# **A1 in Northumberland: Morpeth to Ellingham**

**Scheme Number: TR010059**

## **6.8 Environmental Statement Appendix 10.4 - Drainage Strategy Report Part B (Tracked)**

**Environmental Statement Appendix 10.4 -  
Drainage Strategy Report Part B (Tracked)**

**Figure 4-6 - West Linkhall Road Proposal to use A1 Drainage Network**

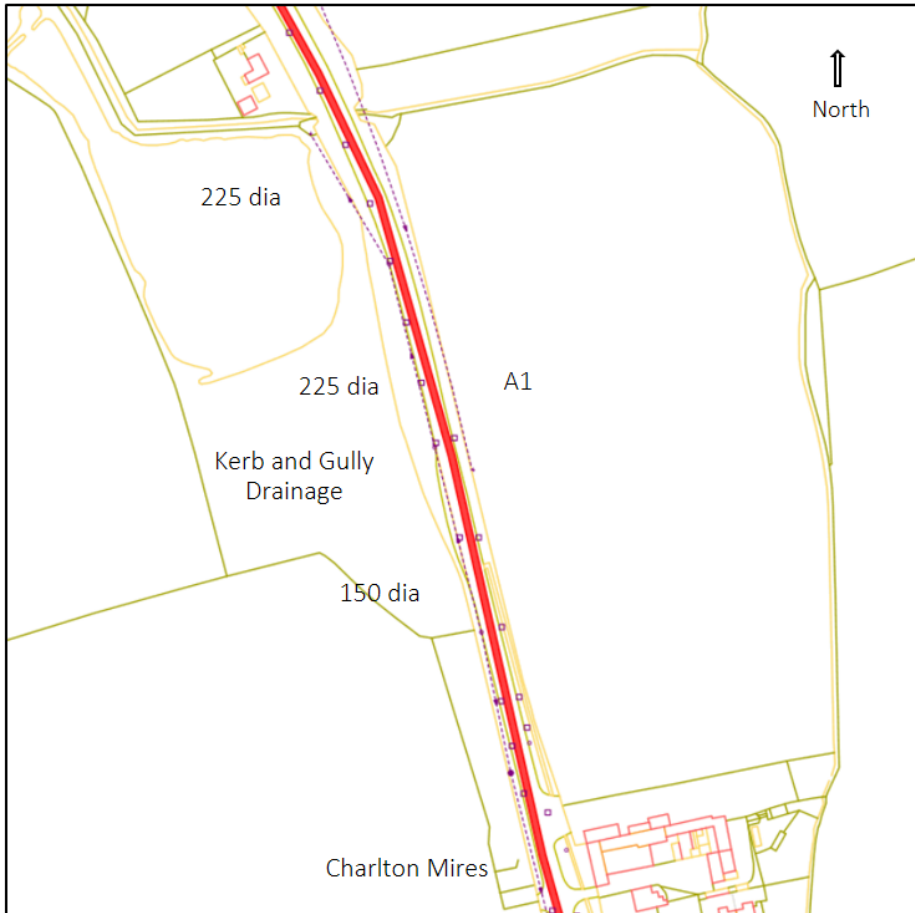
Ref	Meeting Notes	Action By	Date
<b>1.0</b>	<b>Introductions</b>		
<b>2.0</b>	<b>West Linkhall Access Road Updates</b>		
	<p>TO explained changes to West Linkhall Access Road which included:</p> <ul style="list-style-type: none"> <li>- Length of single lane section at pinch point reduced to 125m, with intervisibility between either end;</li> <li>- Single lane section narrowed by 0.6m to 3.9m wide carriageway;</li> <li>- Turning head added to end of access road, suitable for refuse vehicles.</li> </ul> <p>MP: The single lane section of road is relatively straight and traffic flows will be low, but detailed design to consider how it is going to be marked/signed, being careful not to urbanise the road.</p> <p>DL: This is an improvement on the previous design, but the single lane section is still not ideal. However, there are obvious constraints at this locale and so this is acceptable.</p>		
<b>3.0</b>	<b>East Linkhall Access Road Updates</b>

- e.** Two new local roads would be constructed in this area, they are the East Linkhall Road and the West Linkhall Road. These two roads would become the responsibility of the NCC once completed. The East Linkhall Road is to be a two lane road and this necessitates a positive drainage system, the proposed filter drain network is to connect to detention basin DB27a prior to controlled discharge to the tributary of the Kittycarter Burn. It is proposed that the West Linkhall Road, which would be constructed generally on the line of the existing A1 northbound lane, would be drained using the existing A1 drainage system, refer to **Figure 4-6** below.

**Figure 4-7 – Rock South Farm Road**

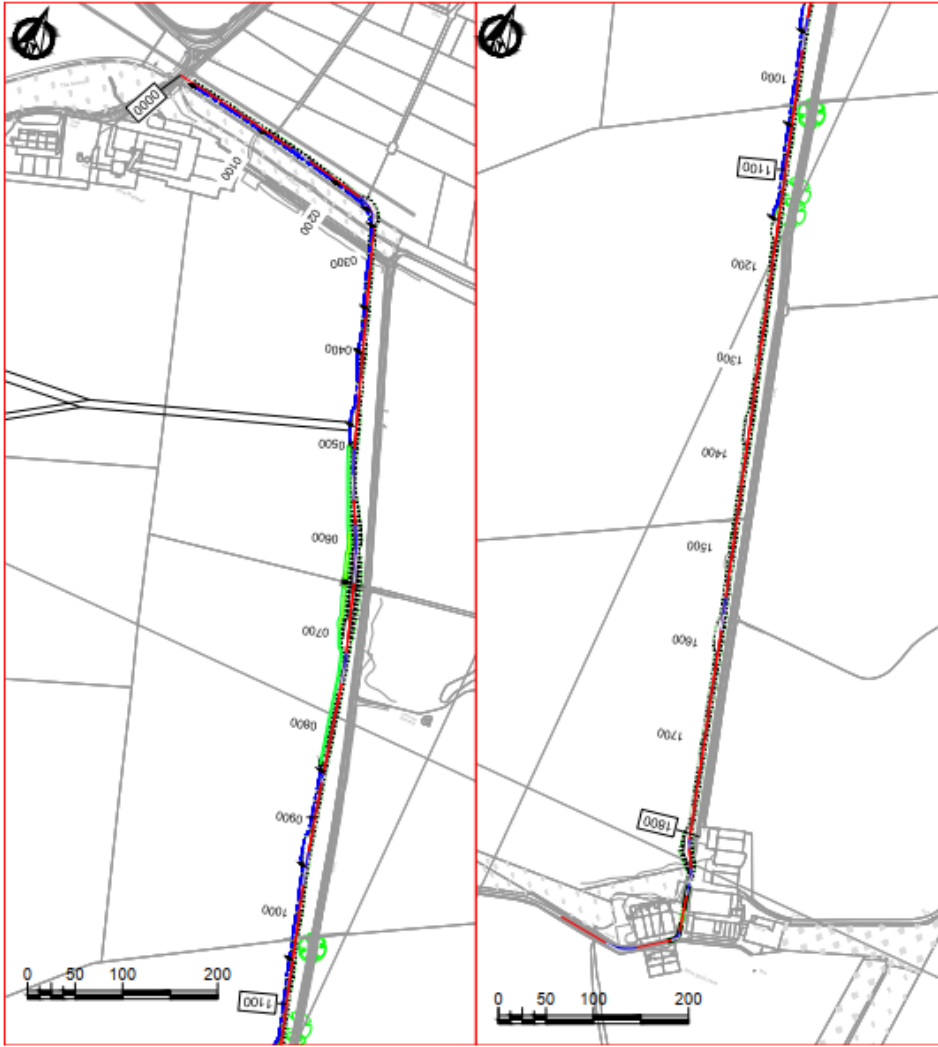
4.0	<p><b>Rock South Farm Access Road Drainage Proposals</b></p>		
	<p>RS provided update following an assessment of the drainage provisions for Rock South Farm Access Road:</p> <ul style="list-style-type: none"> <li>- Provision of positive drainage with attenuation not possible within the Order Limits that have been set, which were based on a design with 'over the edge' drainage.</li> <li>- Possible to provide positive drainage for northern half of access road if discharging straight into the water course – would require approval from the Lead Local Flooding Authority (NCC).</li> <li>- The southern half of the access road cannot be positively drained due to the constraints of the Order Limits and environmental impacts to create detention basin and create a new outfall.</li> </ul> <p>TO: Providing positive drainage for the northern half of the access road would require changes to the vertical alignment outside the vertical Limits of Deviation set for the road (<math>\pm 250\text{mm}</math>).</p> <p>DM: Raising the vertical alignment would take earthworks very close to the Order Limits.</p> <p>DL requested a long section and cross sections for Rock South Farm Access Road for assessment by NCC to determine whether they would be satisfied to adopt the road without positive drainage.</p> <p><b>Post meeting update (23/04/21): Further assessment has determined that positive drainage is unfeasible within the</b></p>	TO	22/04/21

Ref	Meeting Notes	Action By	Date
	<b>constraints of the Order Limits and 'over the edge' drainage is therefore proposed along the full length of Rock South Farm Access Road.</b>		
<b>5.0</b>	<b>Maintenance Limits of adoption</b>		
	<p>Focused discussions around discrete parcels of land adjacent to realigned road. Fenrother free flow could be handed to NCC but Highlaws would remain with HE (essential mitigation area).</p> <p>MH suggested that from his experience on similar schemes this detail can be agreed at the detailed design stage.</p> <p>DL asked if a written record of the methodology of determining adoption can be produced, including what has been agreed at this stage and what can be agreed at the detailed design stage.</p> <p>DM suggested this is picked up in the SoCG as well as a separate note. DM and MH to lead on the development of the note and TO to update the SoCG as appropriate.</p>	DM/MH/ TO	04/05/21

4.4.2. The Rock South Farm development is currently connected to the A1 at Chainage 56750. However, this road is being blocked off and no access will be permitted onto the A1 here. A new NCC-maintained road, referred to as Rock South Farm Road, is to be constructed as part of the Scheme connecting the properties to the Rock Farm to the north. This will be adopted by NCC. There is to be positive drainage to this road as shown on Figure 4-7 below.

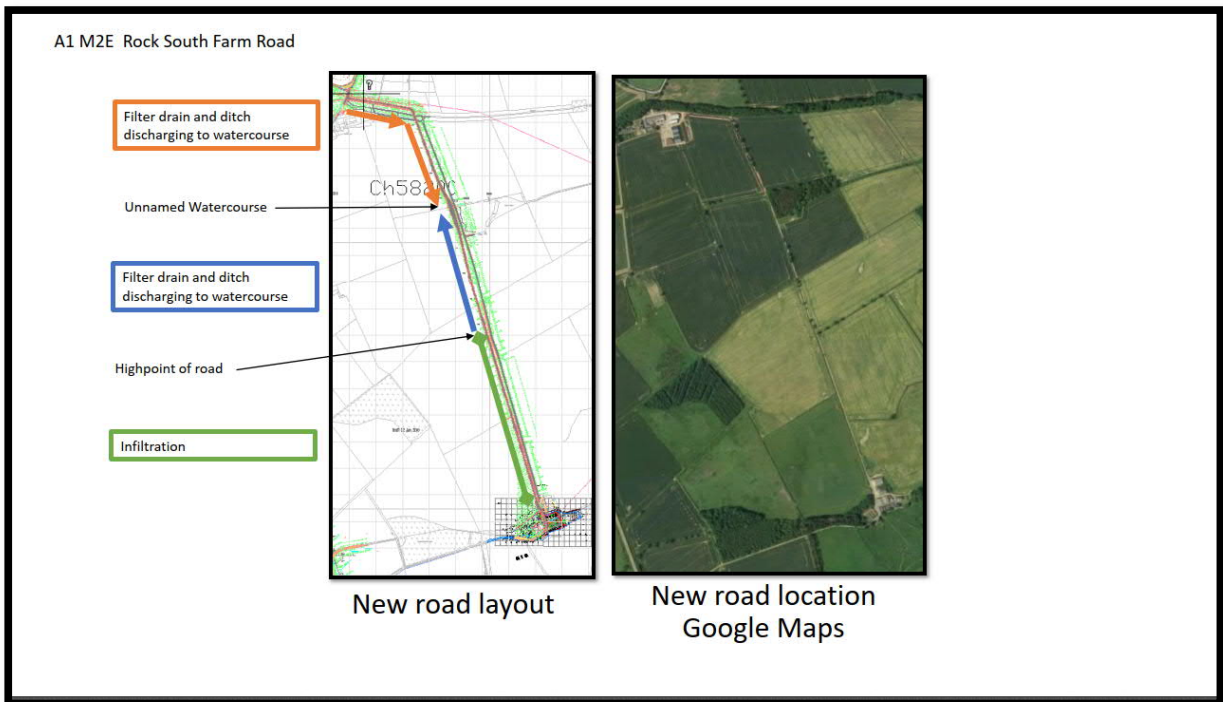
I would like to speak to you to update you on the drainage that is being proposed for Rock South Farm Road.

I have discussed the proposal with James Hitching as the LLFA and he is in agreement with the general design proposal but I wanted to discuss it with you as the highway adopting authority.

We have split the road into three sections see the attached plan.

We will be proposing that the carriageway at the two northern sections will be drained to filter drains/ditches where appropriate and discharge at controlled rates into the unnamed watercourse. There will be ditches to store the runoff before allowing it to discharge.
